American Whitewater
PO Box 63
Springfield, OR 97477

March 2, 2026

RE: Comments on the Draft Environmental Impact Statement for Post-2026 Operational Guidelines and Strategies for Lake Powell and Lake Mead

Figure 1. Map depicting river recreation opportunities in the Colorado River Basin, demonstrating which river segments are directly impacted by CRSP UIU operations and which river segments are directly located in or are directly impacted by the DEIS scope.

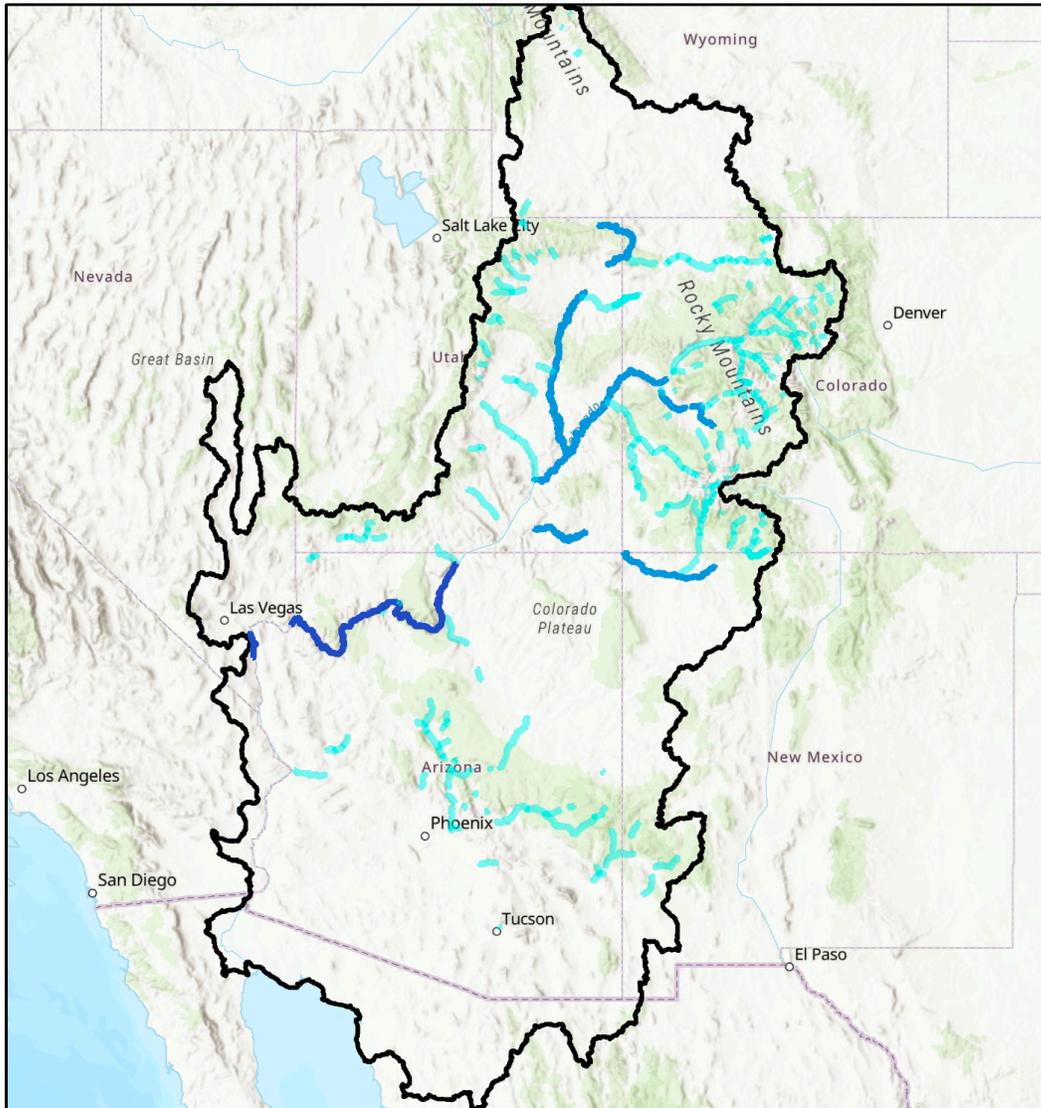
The Continued Current scenario, Basic Coordination Alternatives and Supply Driven alternatives all contemplate releases from the Colorado River Storage Project Upper Initial Units (CRSP UIU).¹⁵ The DEIS is clear that contemplating releases from CRSP Initial Units doesn't expand the geographic scope as any releases would be in accordance with the RODs for each unit. These releases would have significant impacts on the endangered species, the environment and recreational resources below the CRSP UIUs. There are highly sought after river recreational reaches below each of the UIUs that would be impacted by these releases. Please see the map in Figure 1 below illustrating the breadth of whitewater boating opportunities potentially impacted by actions identified in the DEIS.

1. The DEIS analysis should include how the modeled releases can be accomplished under existing RODs and if they can feasibly recur at the magnitude modeled. Identification of potential downstream impacts should be identified.
